#### ADDENDUM NO. 2

#### The Construction of P2S1 Liner Expansion Project at Badlands Sanitary Landfill May 25 2023

This Addendum to the Contract Documents for Construction of P2S1 Liner Expansion Project at Badlands Sanitary Landfill is issued by the Riverside County Department of Waste Resources for the County of Riverside ("County").

SHEET 06 OF 60

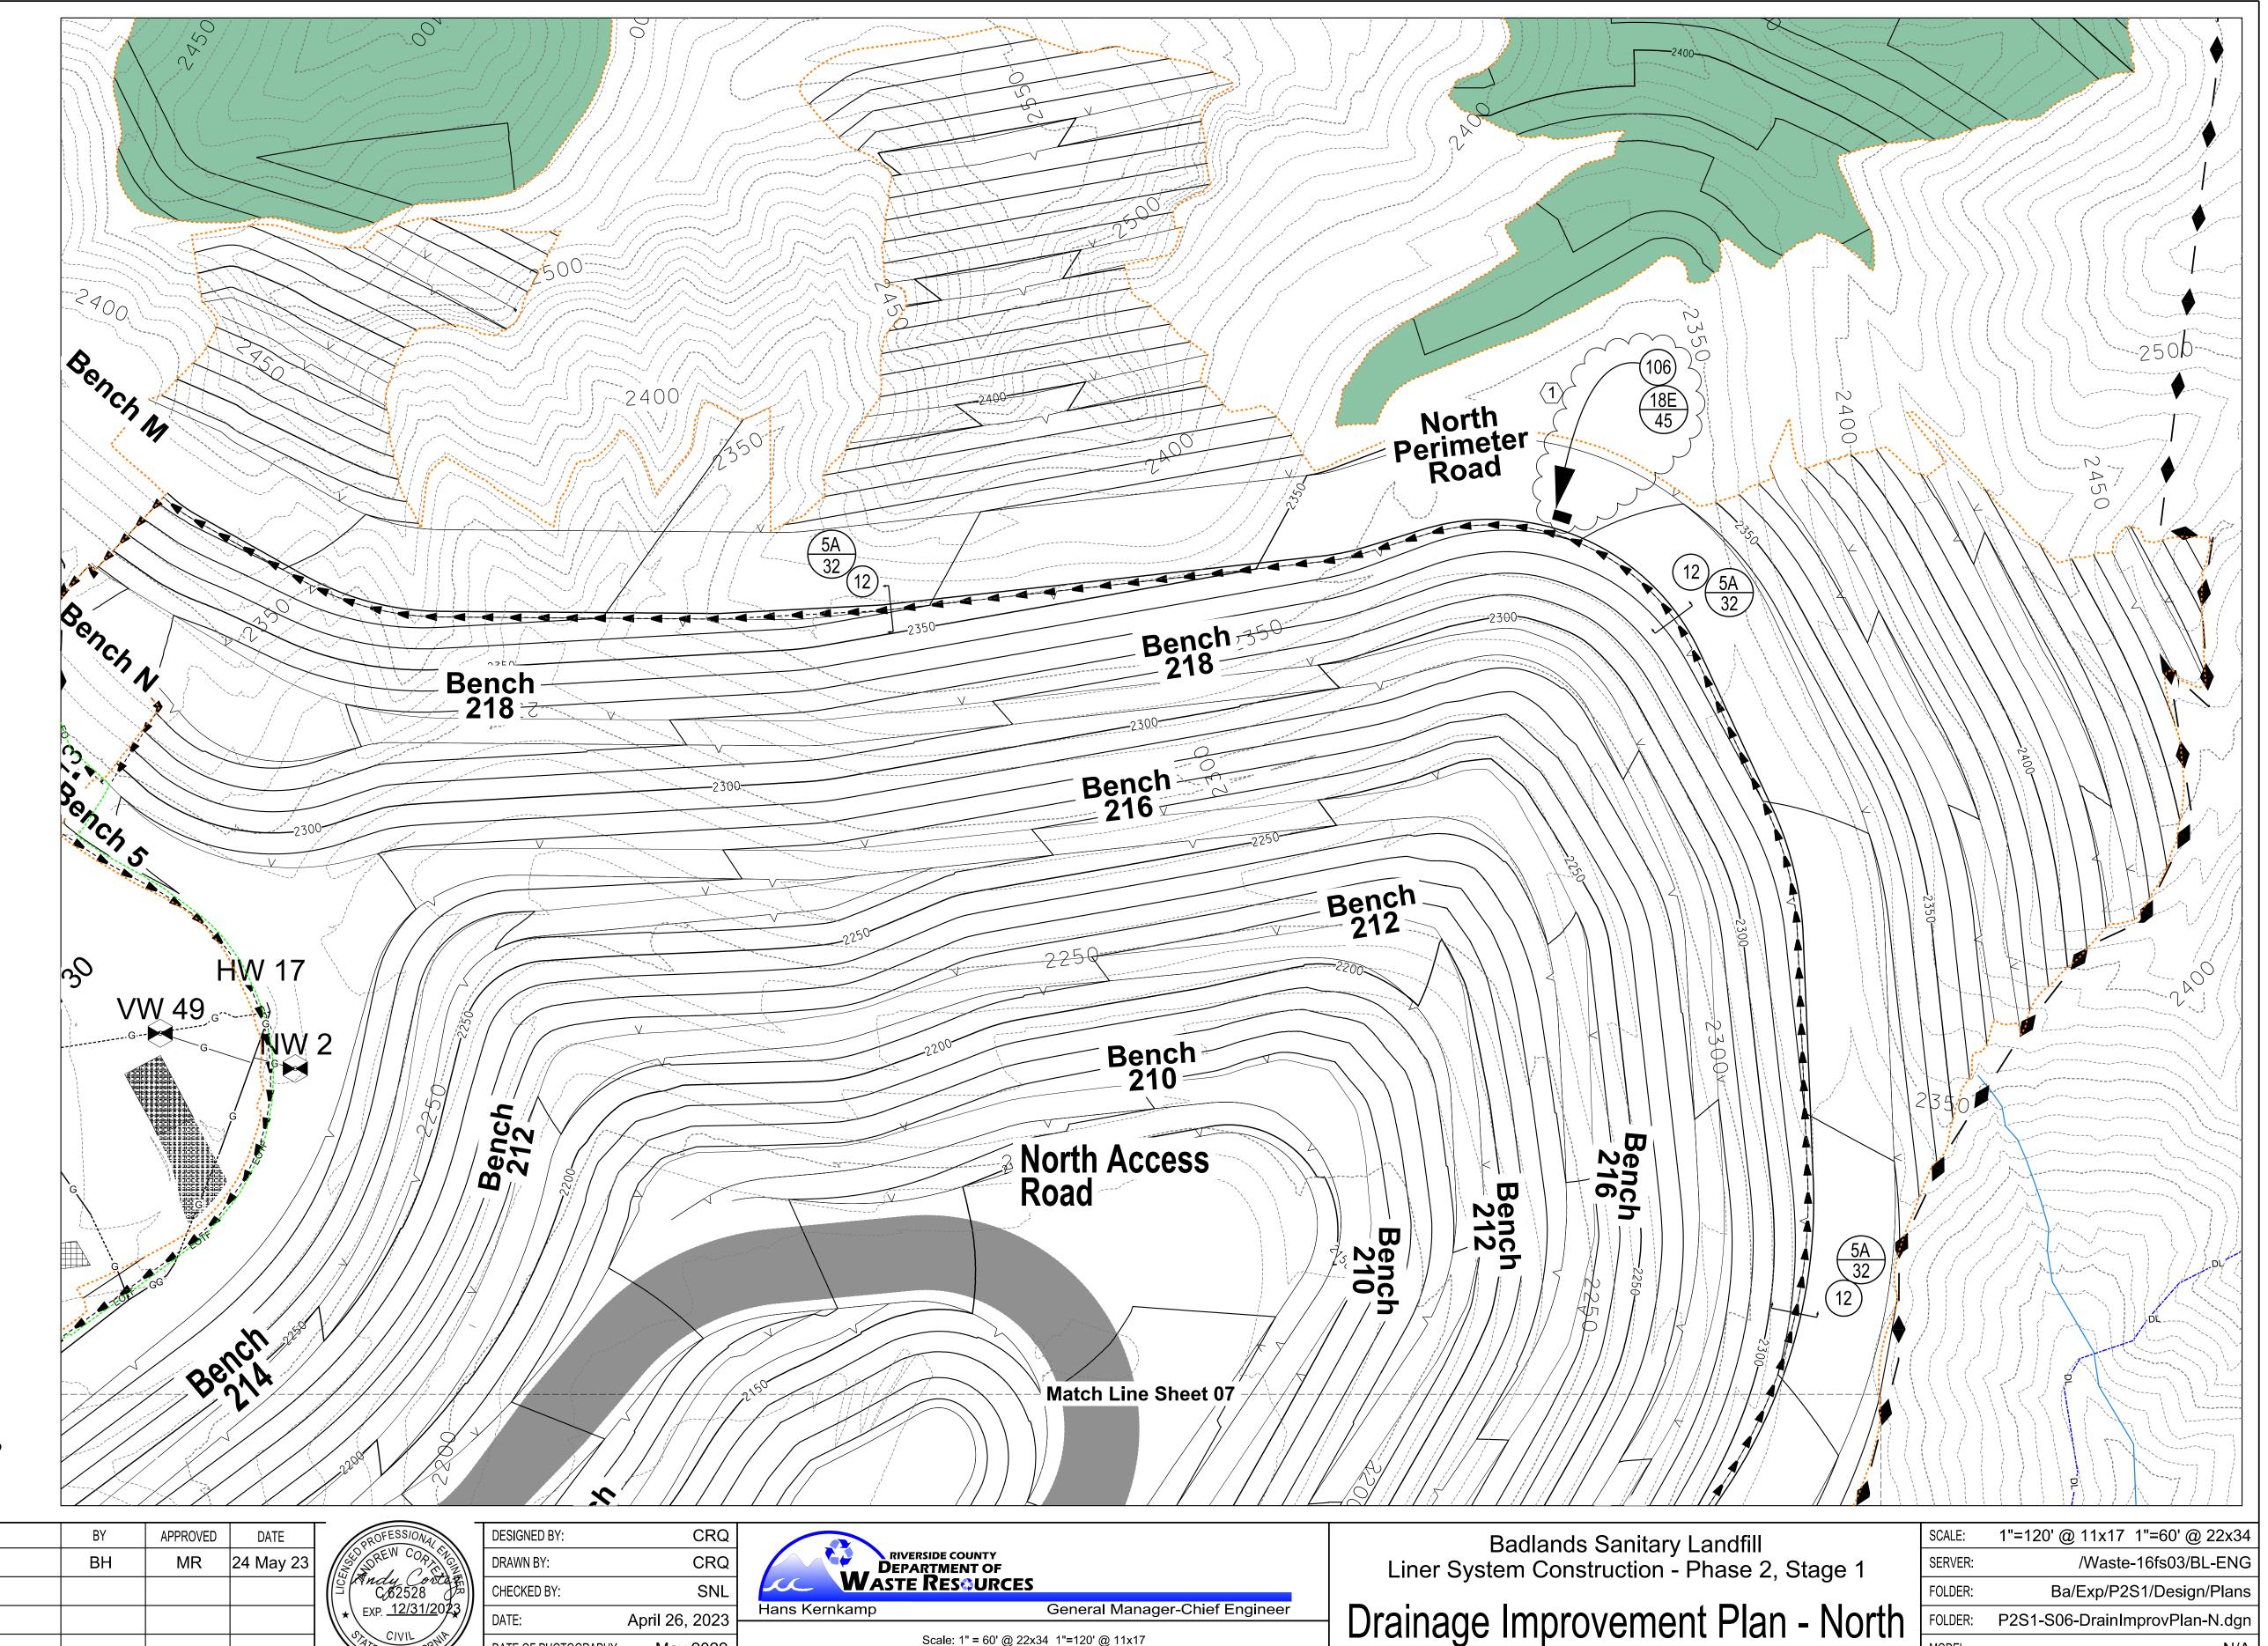
Q2: Detail 18A and Detail 18E on plan page 45 show a box culvert being constructed near the LCRS Clean out, but there is no location of this culvert on the plan pages. Please provide a plan page showing its location as well as the existing drainage system that it ties into.

- <u>Construction Drawing Sheet 6 Box Culvert: Please replace sheet 6 with revised sheet 6. Changes includes: Addition of the box culvert location. The updated construction drawing can be found in attachment 2. Changes include the added location of the Box Culvert. The updated construction drawing can be found in attachment 1.</u>

A2: Sheet 6 of the Construction Drawings has been updated to with the location of the Box Culvert. The Box Culvert shall be placed in-line with parts of the open trap channel along the North Perimeter Road.

Construct Open Concrete Trap Channel (12) Construct Box Culvert from Sta. NPR 10+10 to 10+22. Construct 10 foot transitions along the Open Concrete Trap Channel leading into and out of the Box Culvert. (106)  $\underbrace{1}$

SCALE:	1"=120' @ 11x17 1"=60' @ 22x34
SERVER:	/Waste-16fs03/BL-ENG
FOLDER:	Ba/Exp/P2S1/Design/Plans
FOLDER:P2	S1-S07-DrainImprovPlan-South.dgn
MODEL:	N/A
SHEET 07	OF 60

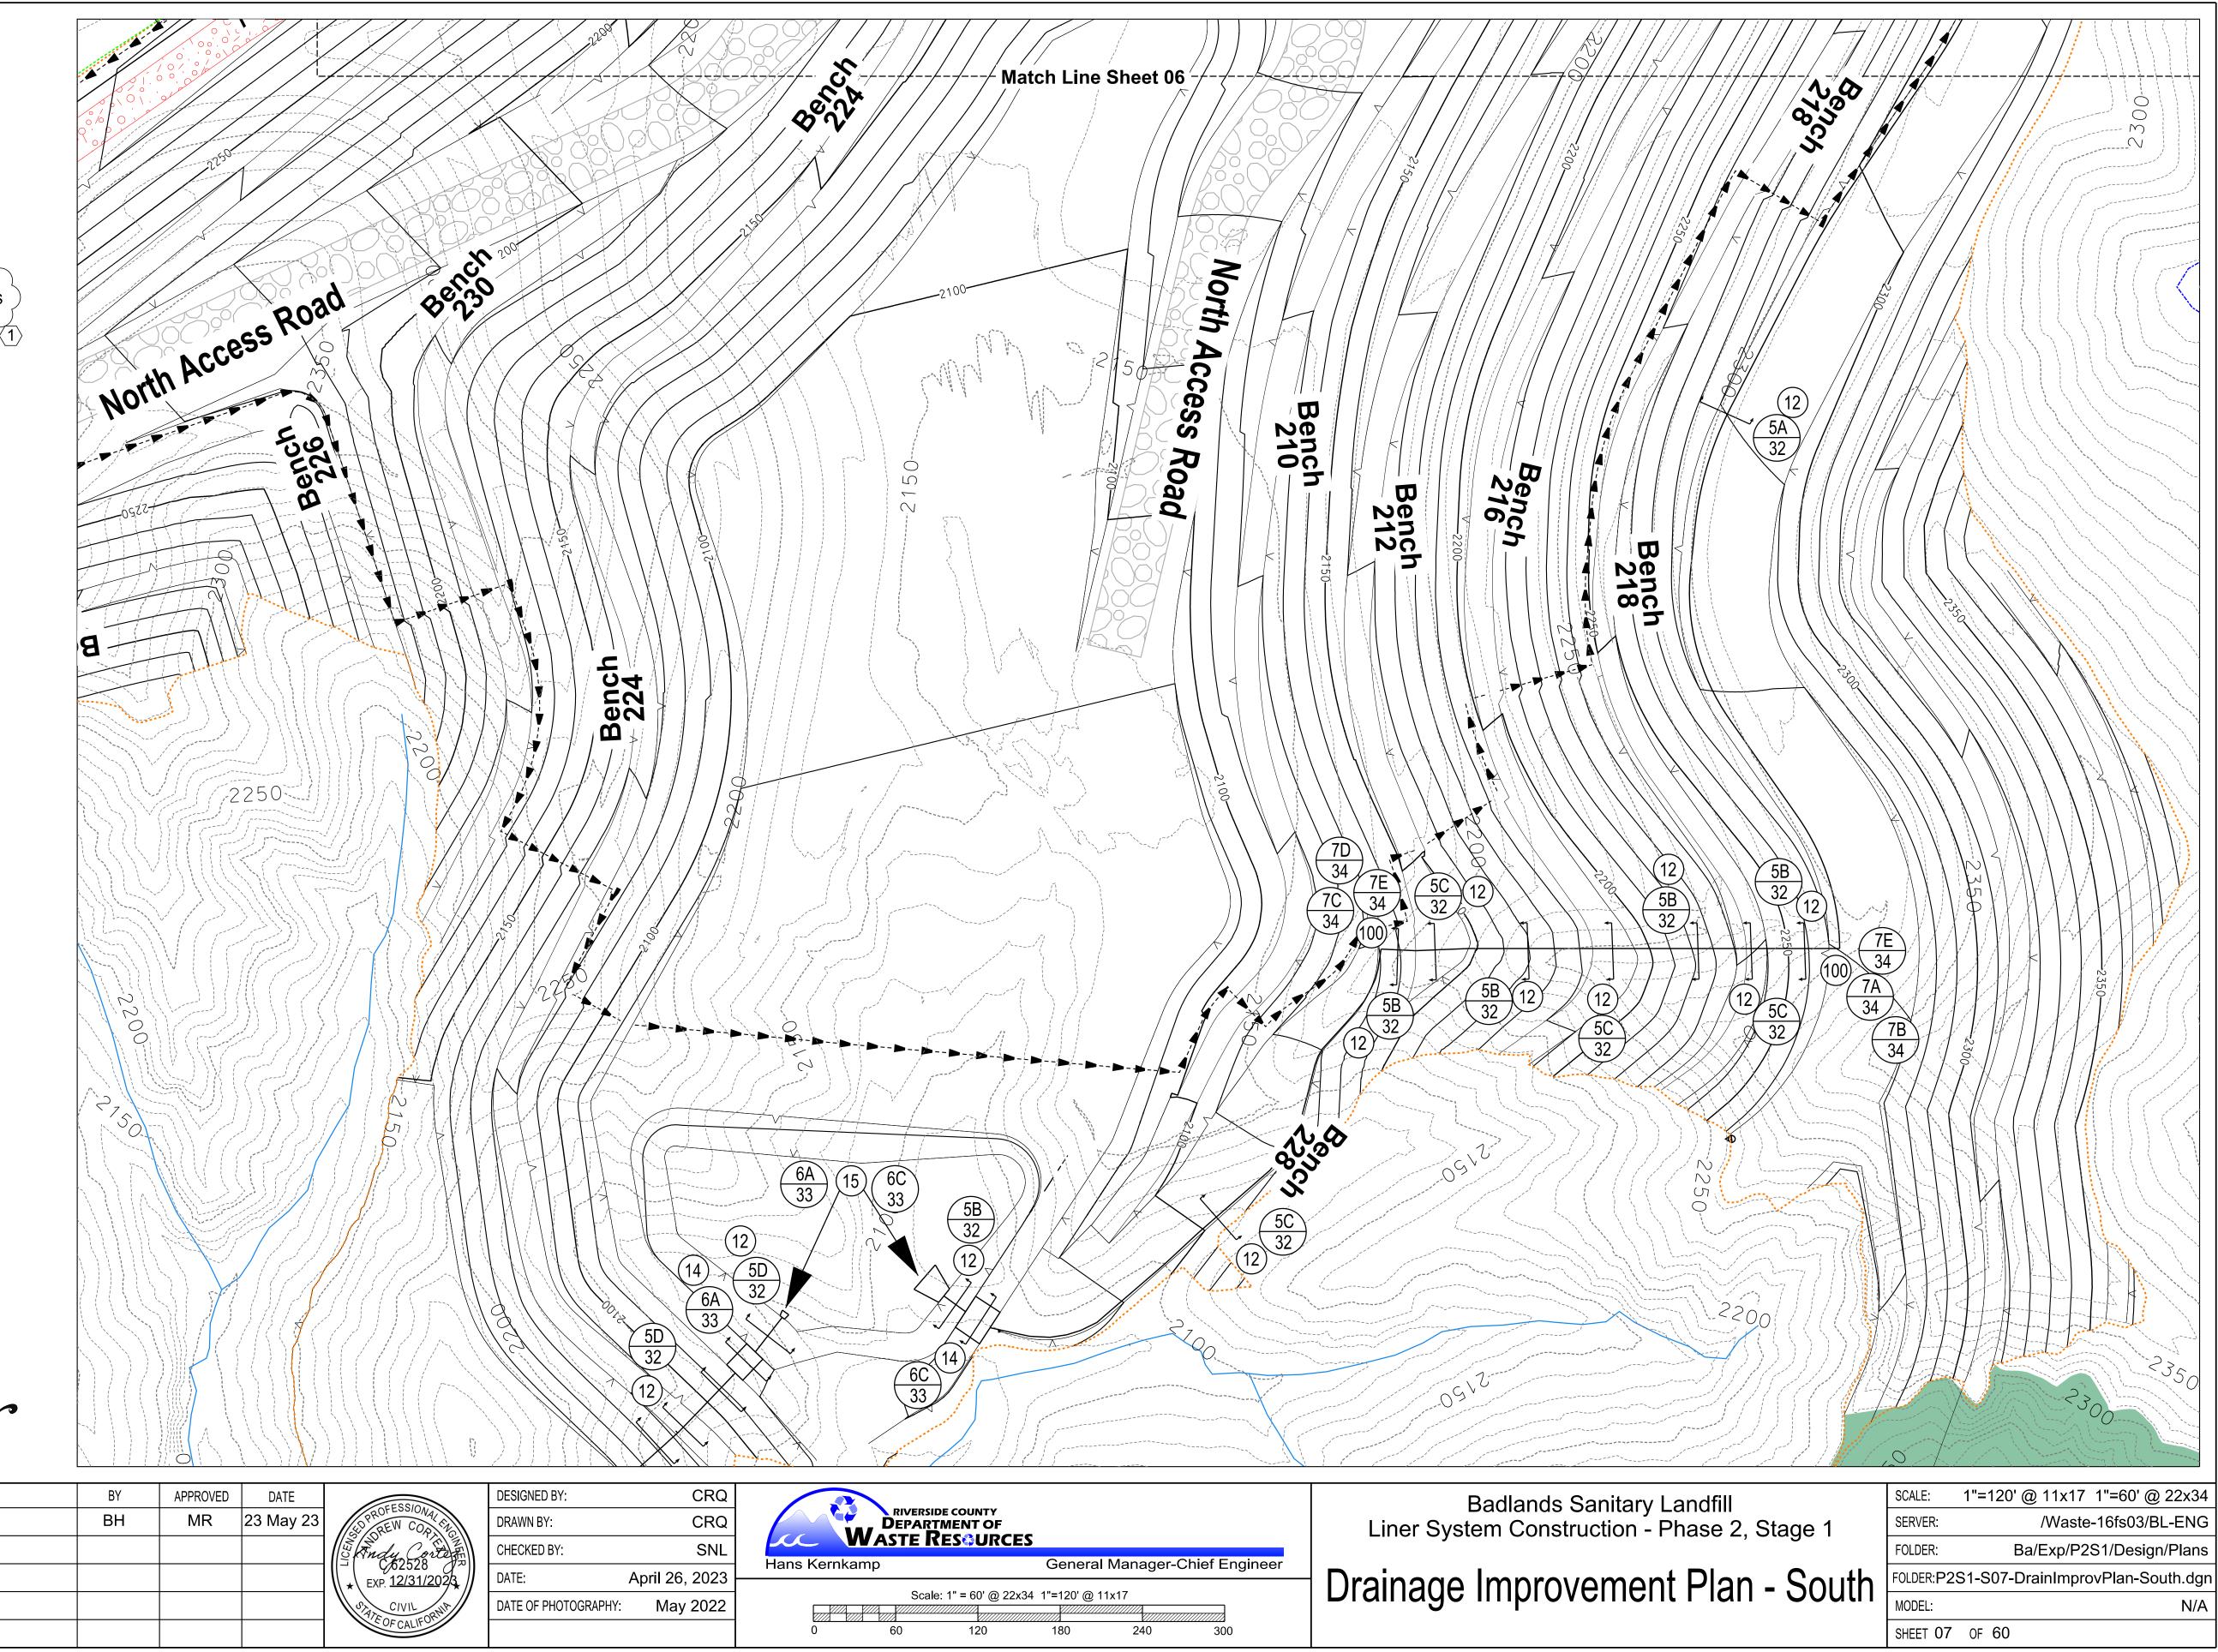
Q13: Plan page 7 shows a plan view of the concrete trap channel. The details show that the channel is to transition from detail 5C to 5B to 5C to 5B and then back to 5C within about 600 LF. The detail 5B channel has a depth of 2.0' and the 5C channel has a depth of 3.25'. It will be extremely difficult to construct a channel on grade that properly flows with the depth fluctuating that drastically and that often. Would the owner consider utilizing one size of trap channel for this work or utilizing a more gradual transition?

- 6. <u>Construction Drawing Sheet 7 Drainage Channel Transitions: Please replace sheet 7 with revised</u> <u>sheet 7. A construction note regarding drainage channel transitions has been added. The updated</u> <u>construction drawing can be found in attachment 1.</u>

**A13:** Sheet 7 has been updated with an additional construction note which states, "All slope drains shall transition for 10 feet before and after the portions of drains on benches unless noted otherwise."
